# CONSTRUCTION DOCUMENTS QUICK N CLEAN

## PARKER RD. & PINE LANE AVE.

## UTILITY PLANS

CONSTRUCTION DOCUMENTS

OVERALL UTILITY PLAN  
 SHEET TITLE  
 SHEET NUMBER

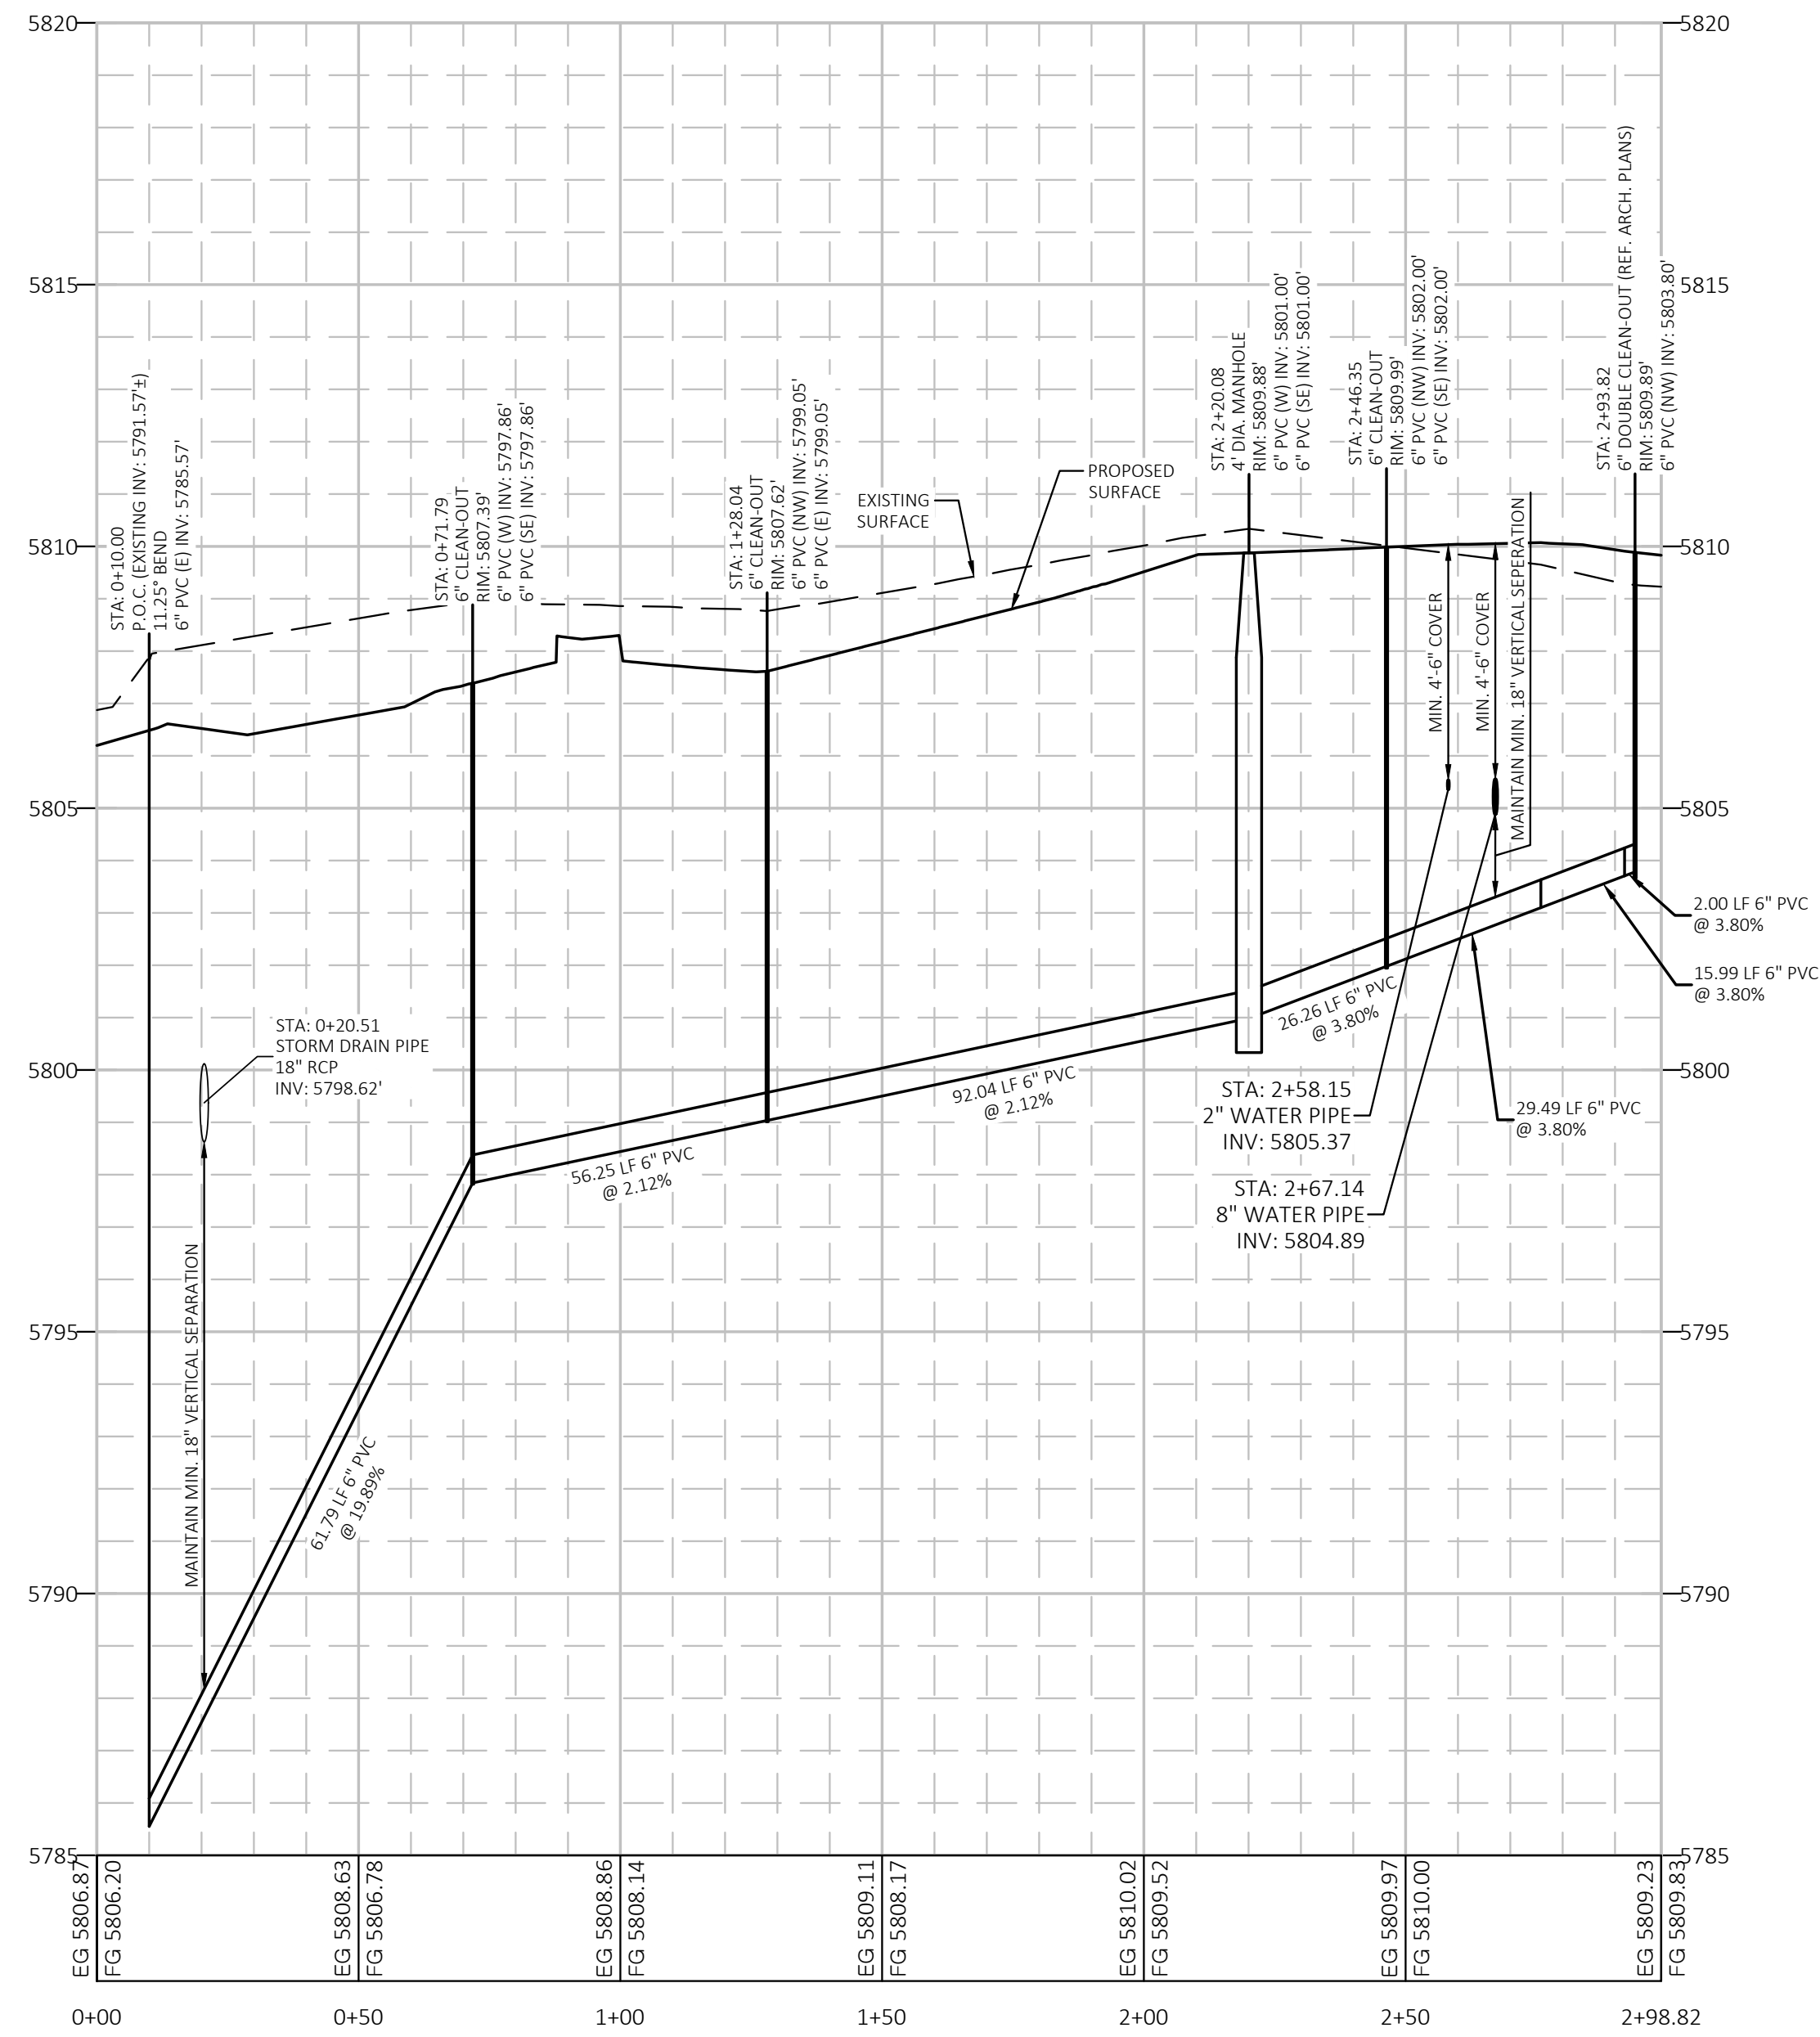
CEI RESPONSE:  
 UPDATED CALLOUT.  
 REMOVED SANITARY SEWER  
 MANHOLE DETAILS FROM  
 LEGEND AND DETAIL  
 SHEETS.
